Addendum No. 1

RE: Contract # C204082

Dare County (F-5700)

Construct 183'-7" X 46' X 10'-6" Passenger/Vehicle Ferry

BODY PLAN

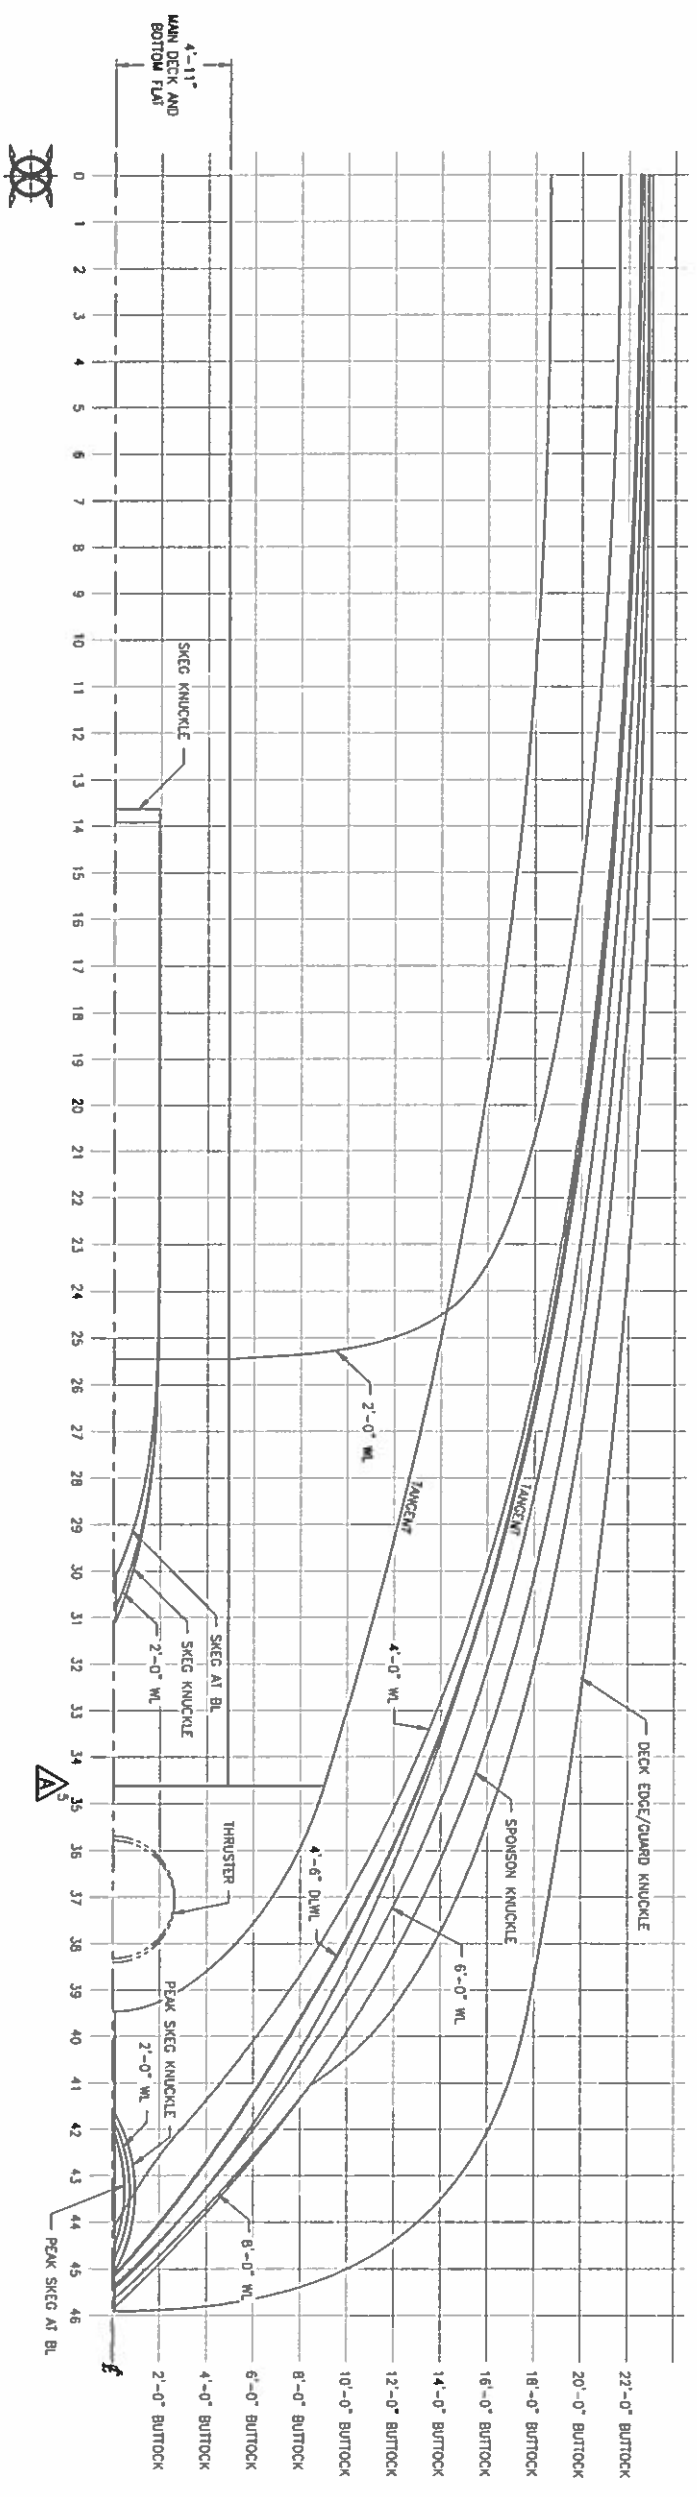
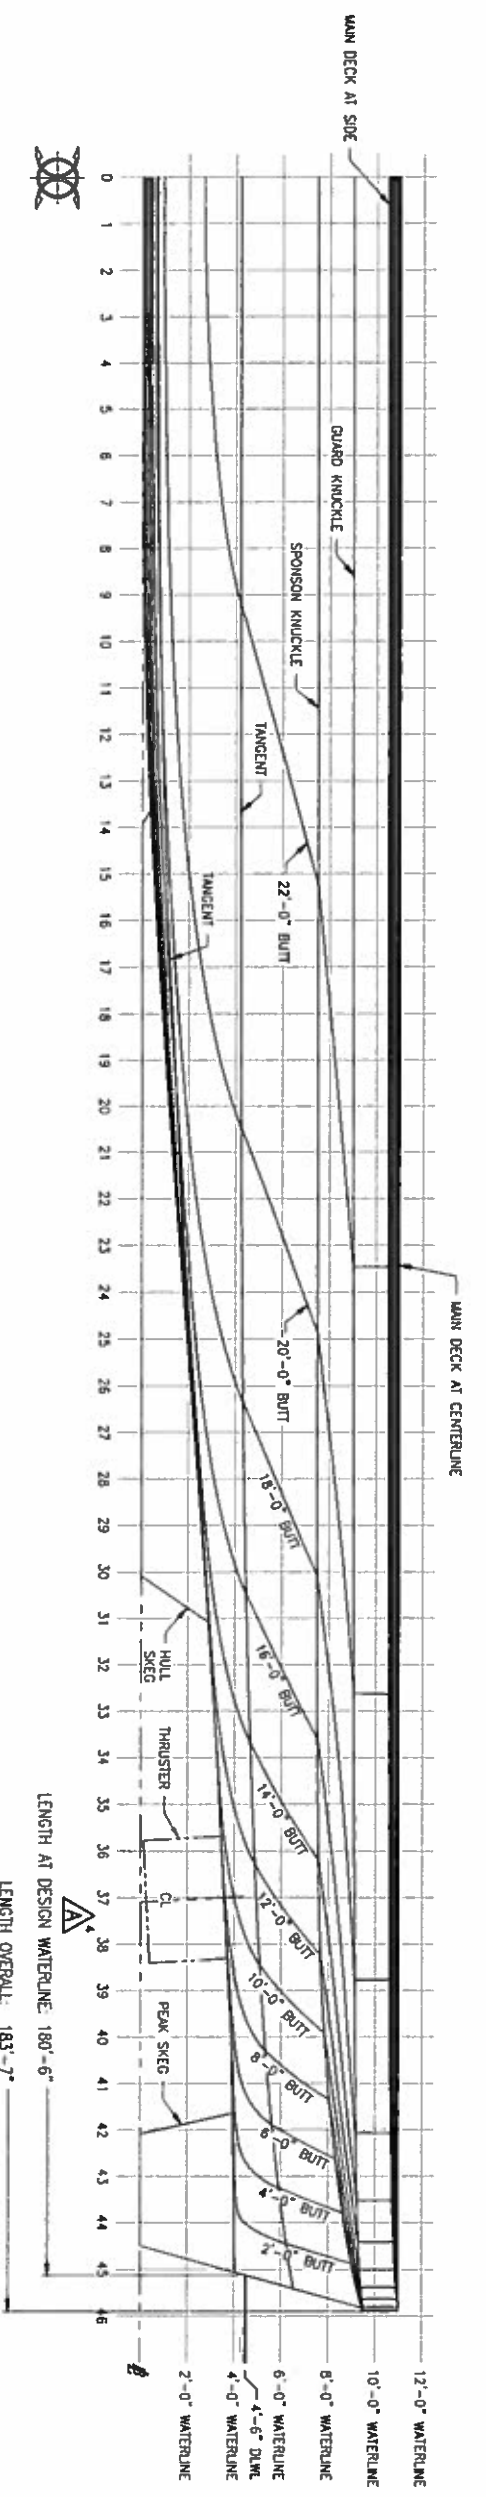
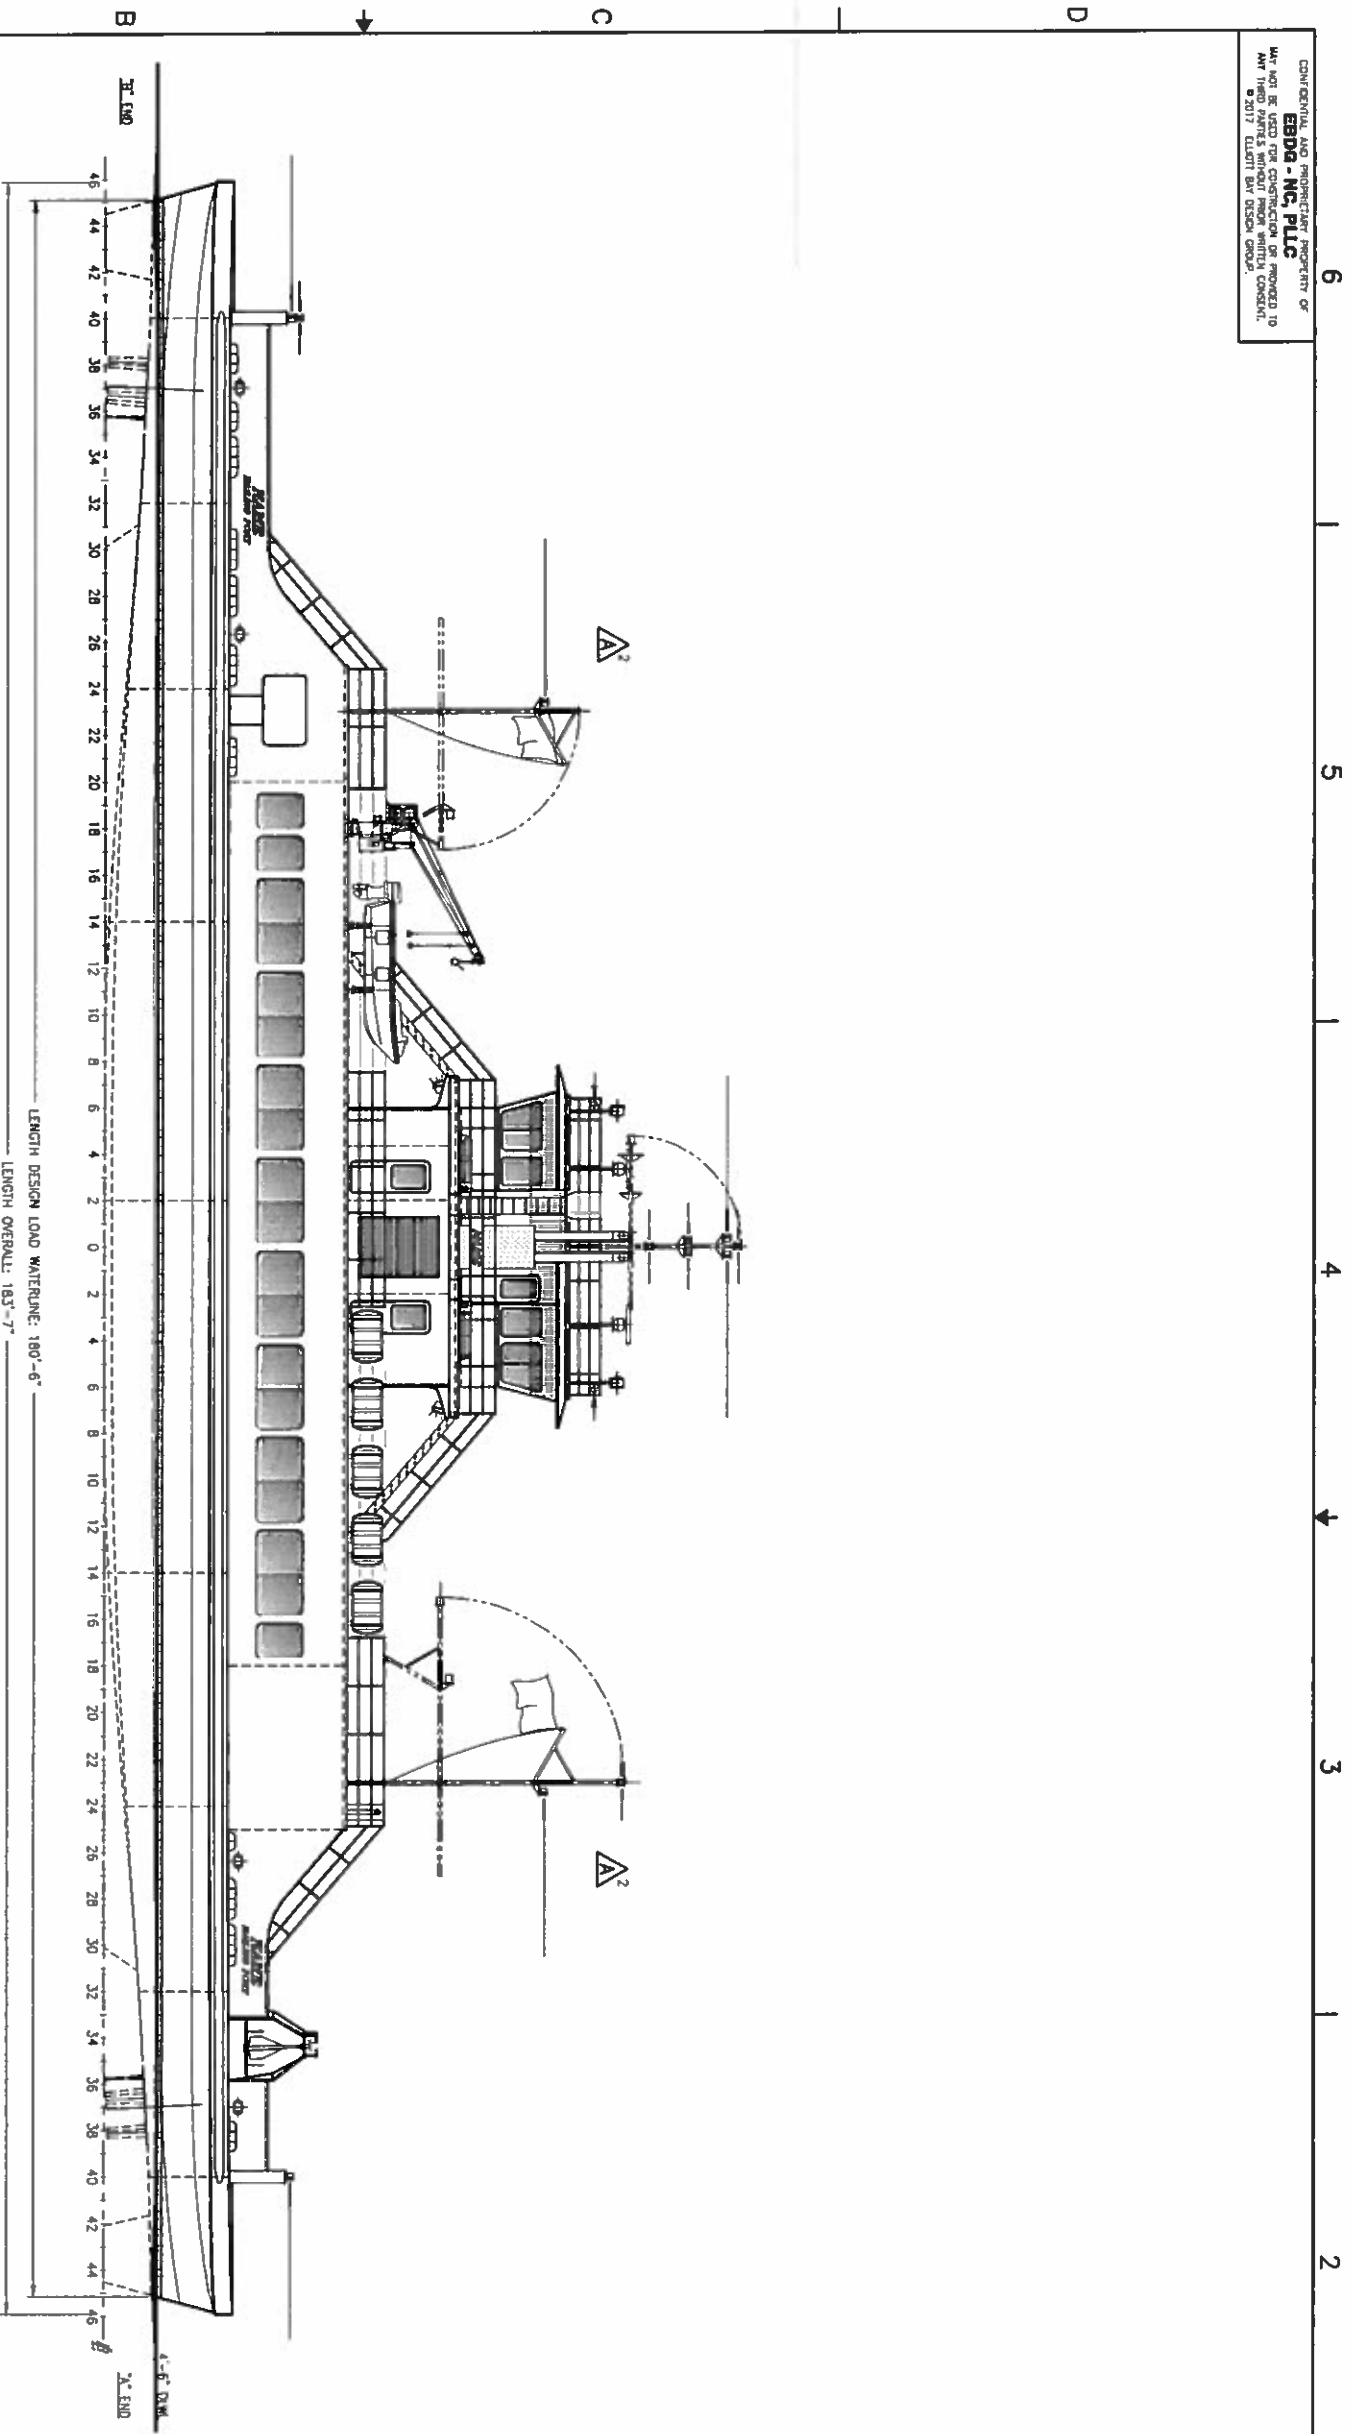
Sheet No.	Revisions
	Lines Plans
100-1: Sheet 1, Zone 2B	Removed 10' and 12' waterlines from body plan
100-1: Sheet 1, Zone 3B	Updated description of bilge tangents
100-1: Sheet 1, Zone 5B	Added transverse chine line to flat hull
100-1: Sheet 2, Zone 2A	Added thruster CL Frame 37 to shear plan
100-1: Sheet 2, Zone 2C	Added transverse chine line to flat hull
	Profiles and Deck Arrangements
101-1: Sheet 1, Zones 3B & 5B	Relocated masts to Frame 23
101-1: Sheet 2, Zone 3C	Added camber and tumblehome dimensions to midship section
101-1: Sheet 3	Updated chock and cleat locations in main deck plan; added hatches to main deck and hold plan views and added tank capacities to hold plan
101-1: Sheet 4, Zone 1D	Added grab-rail to pilot house console detail
101-1: Sheet 4, Zone 2D	Modified pilot chair location / size in pilot house console detail
	Bottom and Side Shell
110-1: Sheet 2, Zone 4D	Reversed position of keel coolers about midship

REV	ZONE	DESCRIPTION	DWG	DATE	APVD
1	A	1. UPDATED PE STAMP FOR REV A.			
2		2. UPDATED DESCRIPTION OF BLDG TANGENTS.	DWG	08/31/17	KJ
3		3. REMOVED 10' AND 12' WATERLINES FROM BODY PLAN.			
4		4. ADDED THRUSTER CL AT FR 37 TO SHEAR PLAN.			
5		5. ADDED TRANSVERSE CHINE LINE TO FLAT HULL PLATE.			
2-2C

PLAN 2-3A
MAIN DECK - 'B' END
 SCALE: 1/4" = 1'-0"

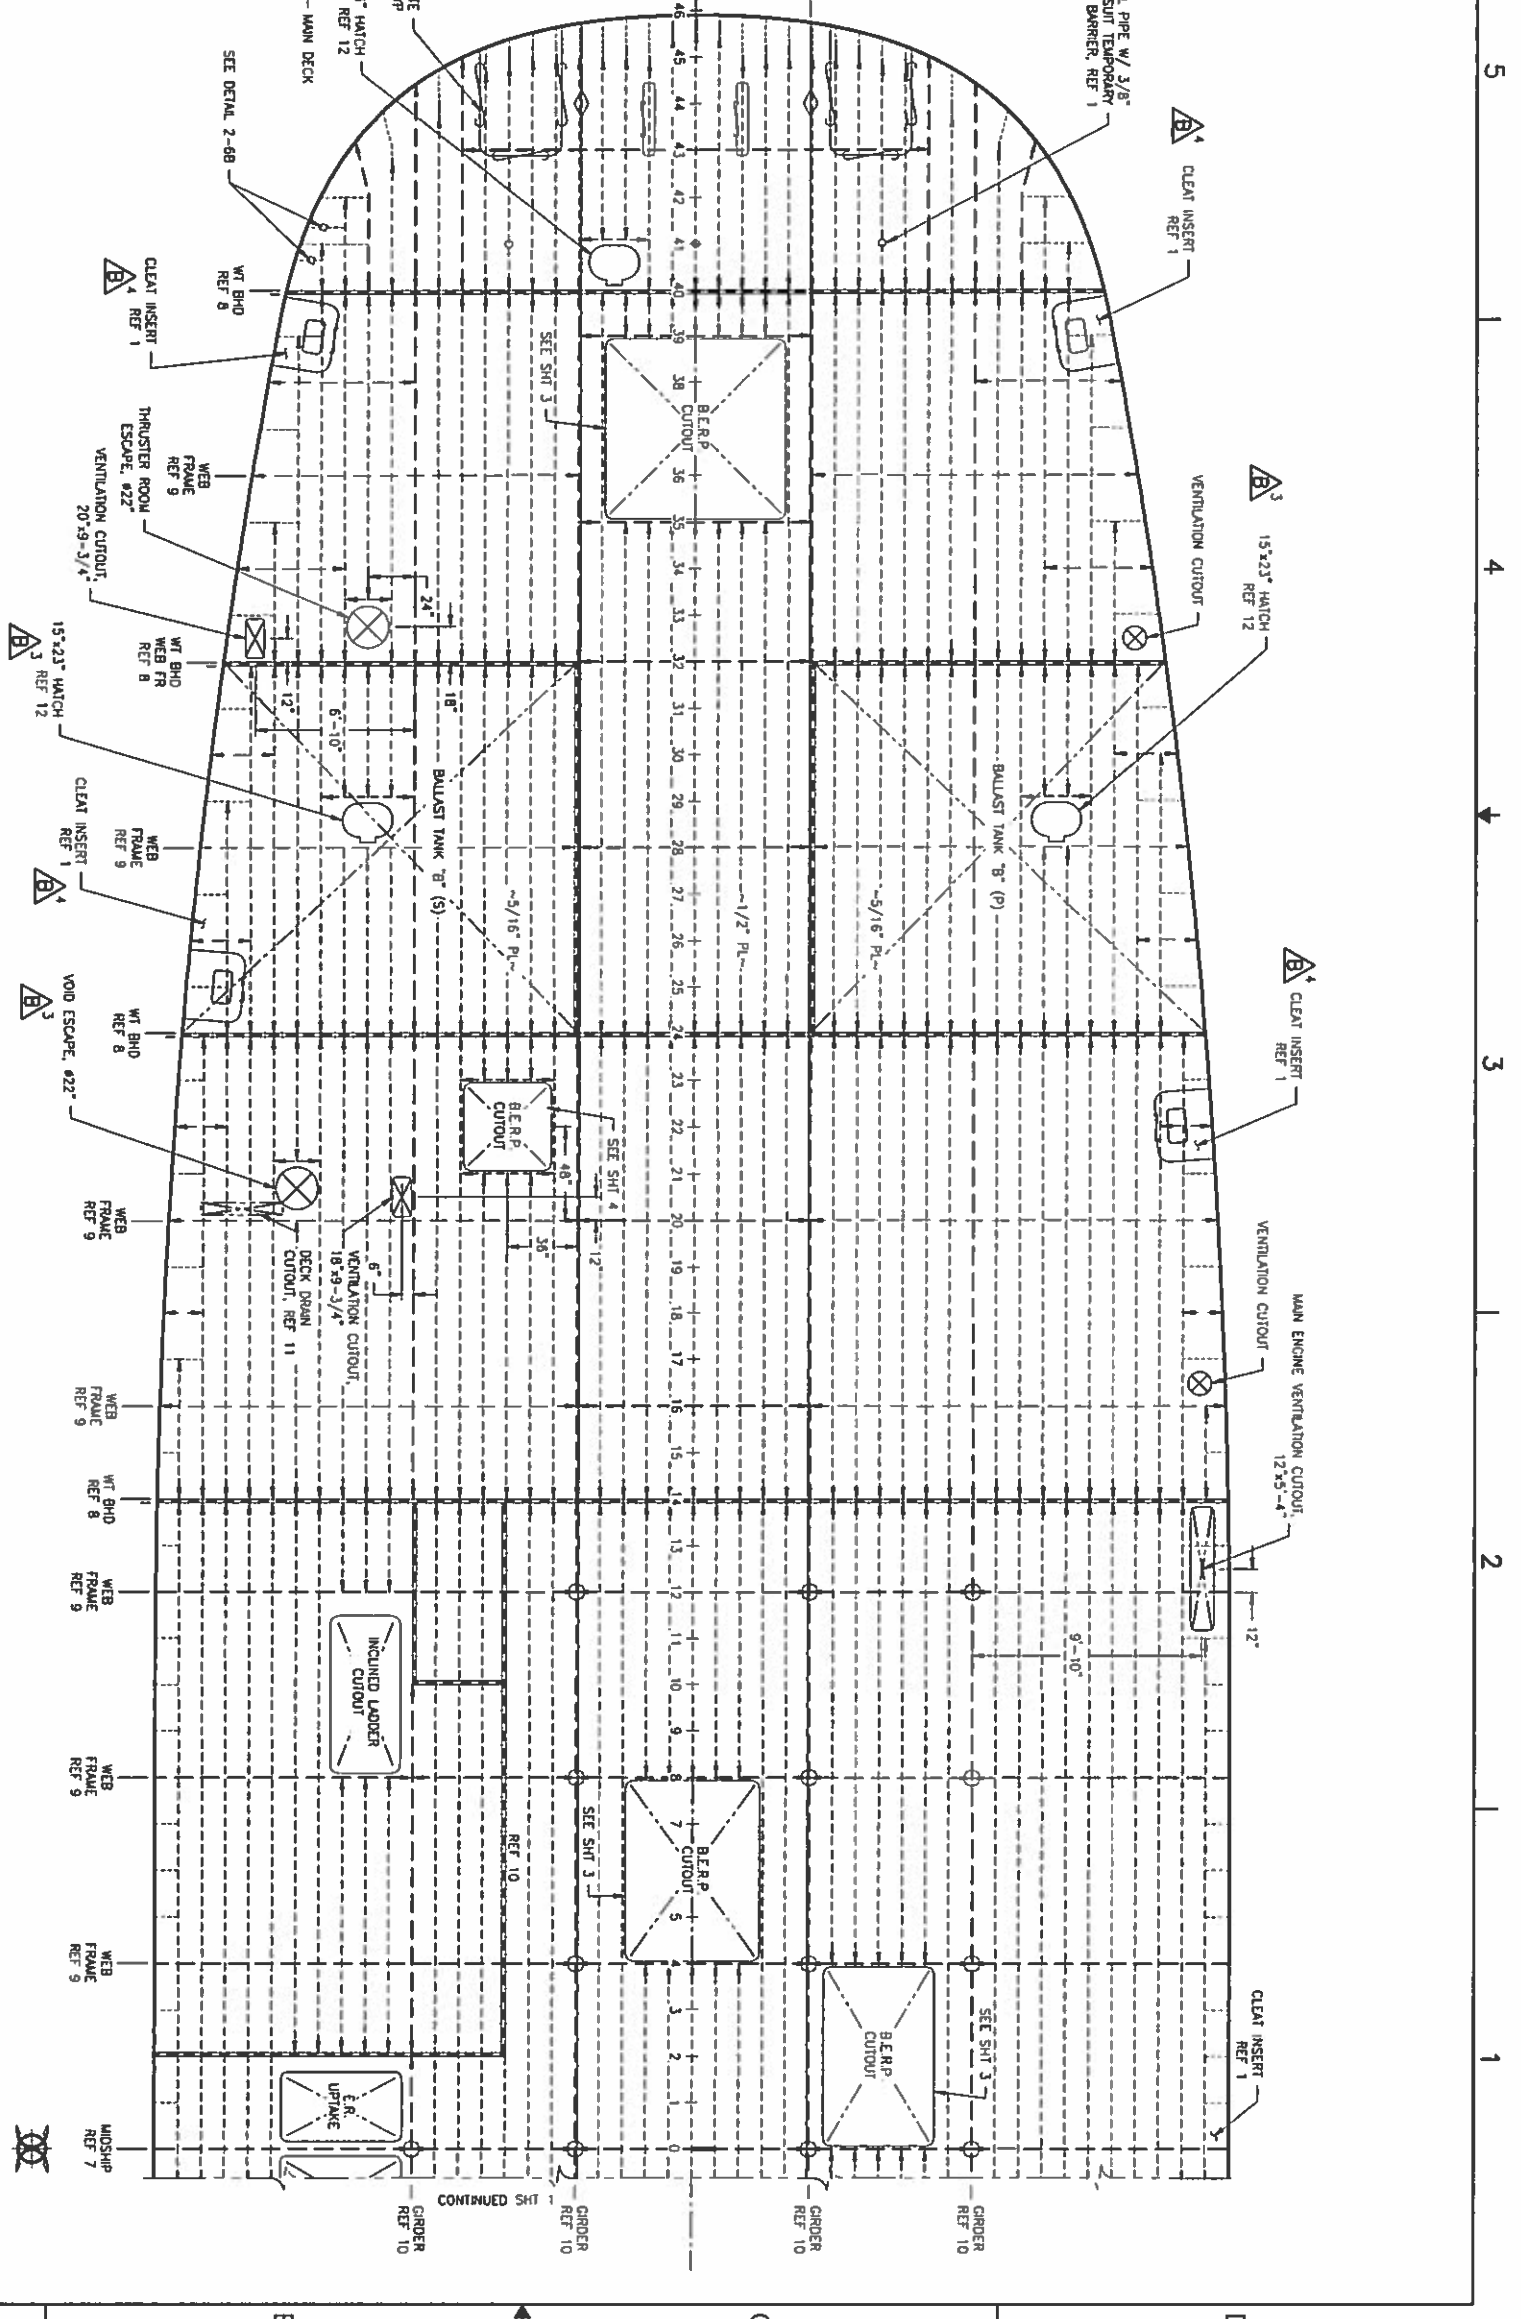
REV	ZONE	DESCRIPTION	DRWN	DATE	APVD
A	1-4A	1. CORRECTED DECK PLATE THICKNESS	PPF	7/28/17	PPF
B	2-3A	1. UPDATED PE STAMP FOR REV B. 2. UPDATED MATERIAL DESCRIPTION OF INSERT PLATES AT ENDS TO STAINLESS STEEL 3. ADDED MANHOLES AND HATCHES 4. UPDATED LOCATIONS OF CLEAT INSERTS	DWG	8/31/17	KAJ
C	1-4A				
D	2-3A
